BRITISH GLIDING ASSOCIATION

TECHNICAL COMMITTEE

TNS 2/3/81

TM 306-15

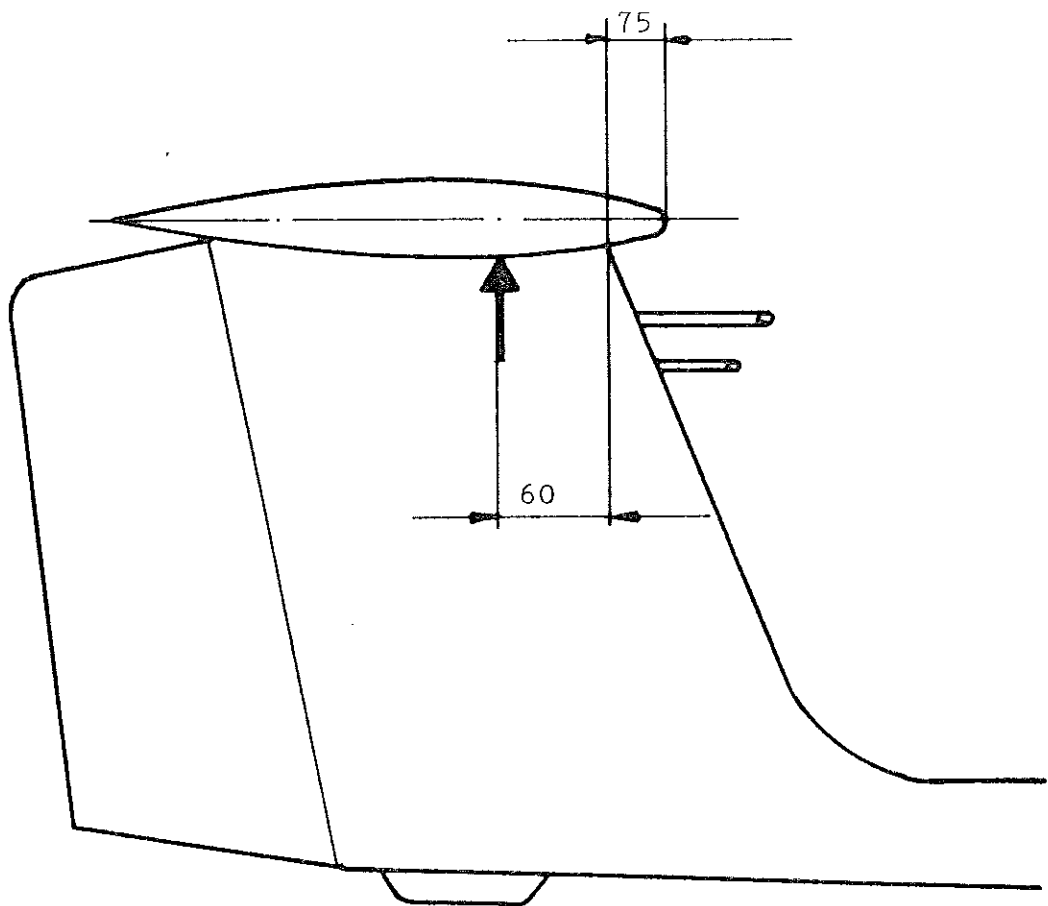
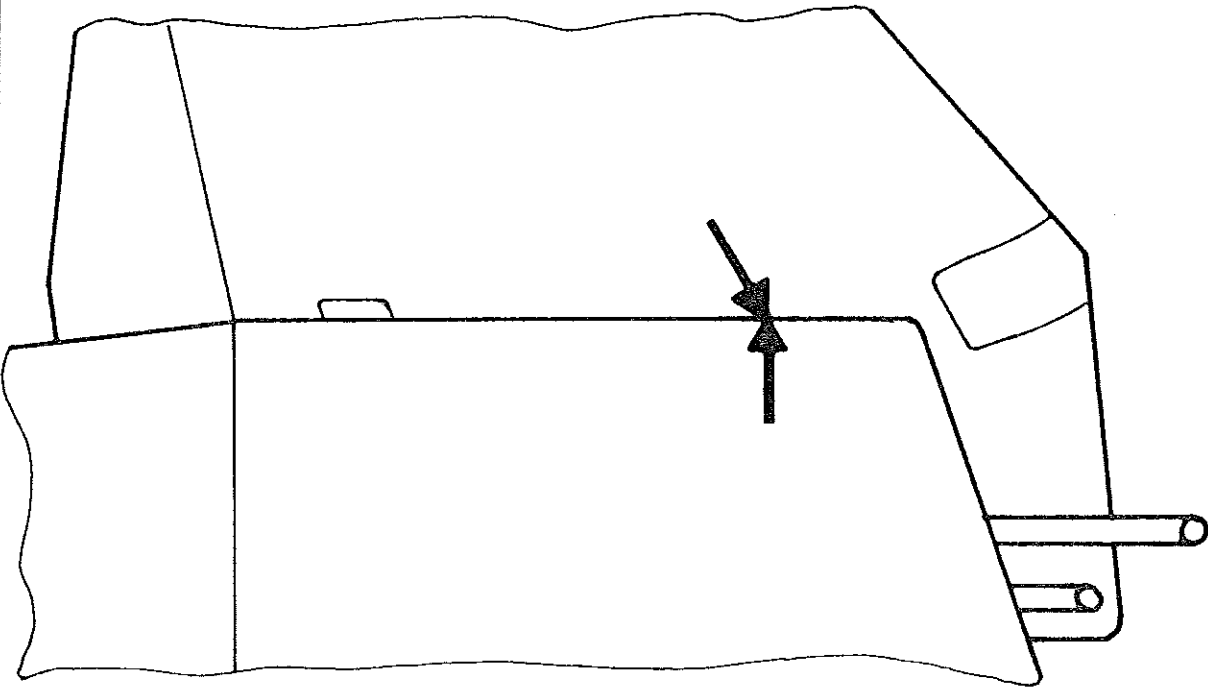
Subject: Marks to control the correct mounting of elevator.

Reason: This action should be taken to ensure correct markings at elevator-tabs and fin, to control correct elevator assembly-mounting.

- Instructions:
- 1a) Mounting elevator section according to Flight Manual page 23. It is important to ensure, that the larger opening of the conical crillings in the inner rings of the horizontal stabilizer spar bearings fall to the rear.

- 1b) Provided the 4 markings at elevator and fin are still existing they must coincide after correct mounting. The former badly adhevent markings should be removed and replaced by new ones at the same position.

- 1c) Provided the 4 markings at elevator and fin are missing completely or partially, the rest of the previous marks should be removed and replaced by new markings according to construction drawing. Before applying glue make sure that the region is free of oil, grease or rest of former labels.

- 1d) To attach the new marks, it is necessary to remove the paper cover before rubbing the arrow firmly with the transparent foil. Then the foil should be carefully removed and the mark again pressed. After 24 hours the adherence is sufficiant enough to withstand application of sealing tape between stabilizer and rudder. There is no risk to remove the marking inadvertently when removing the tape.

INDUCTION SYSTEM FLEXIBLE AIR DUCTS

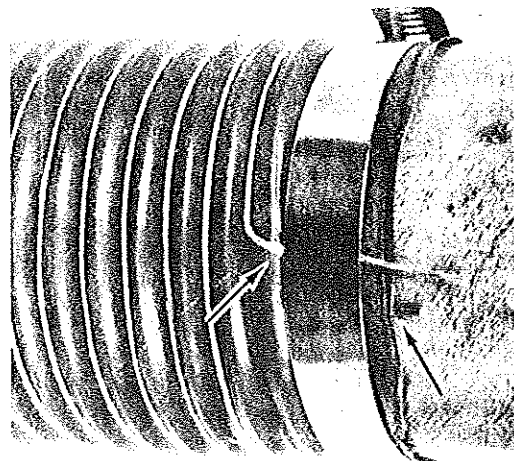
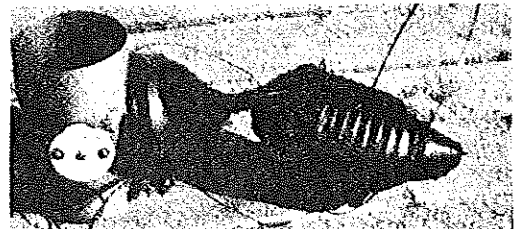
The Beech B23 aircraft engine lost power, resulting in a landing short of the runway. An investigation revealed the air duct from the carburetor heat box to the carburetor had collapsed, stopping air flow to the carburetor.

"Several incident and accident reports have been received which were attributed to the failure of the flexible air ducts installed on Cessna single-engine aircraft. Some of the reports indicated the hose assembly collapsed, resulting in loss of engine power.

"To prevent the possibility of restricting air flow through the engine air induction system, it is recommended the duct assembly be examined each 100 hours. Inspect for such duct deterioration as separation of inner lining, broken or frayed cord wrapping, evidence of hose collapsing, indication of reinforcement wire slippage, or evidence of wire not being properly bonded to the duct. Replacement of defective duct assemblies should be accomplished properly when any indication of deterioration is evident.

"The Cessna Aircraft Company provided this photograph to illustrate how they recommend the flexible ducts be clamped. Please note that the ends of the inner reinforcing wire and the outer cord are turned 45 degrees to normal and are secured by the clamp."

ASTIR T/P BALL.

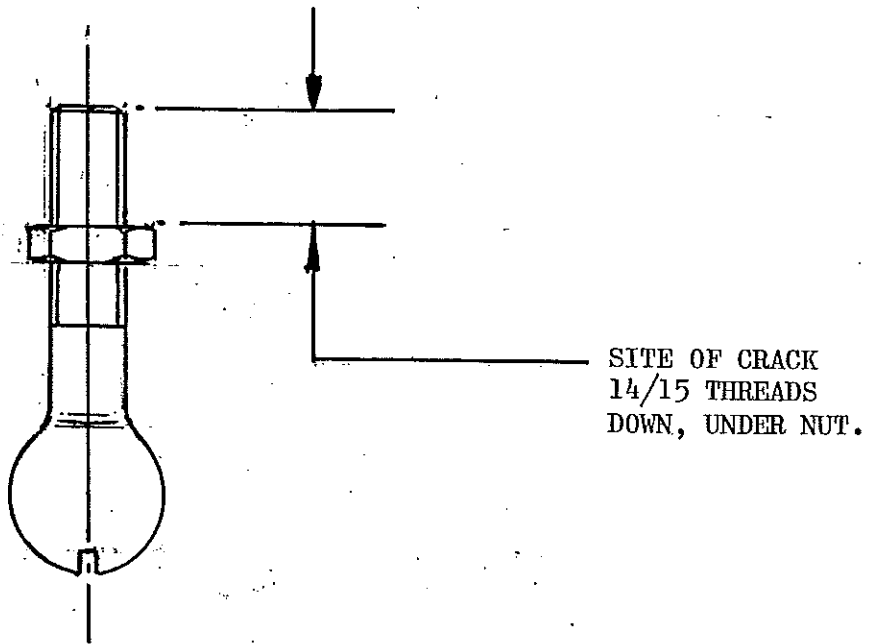
TAILPLANE ATTACHMENT BOLT FOUND CRACKED BETWEEN  
14 & 15 FROM START OF THREAD. THERE IS NO  
PREVIOUS HISTORY OF A GROUND LOOP ON THIS  
MACHINE.
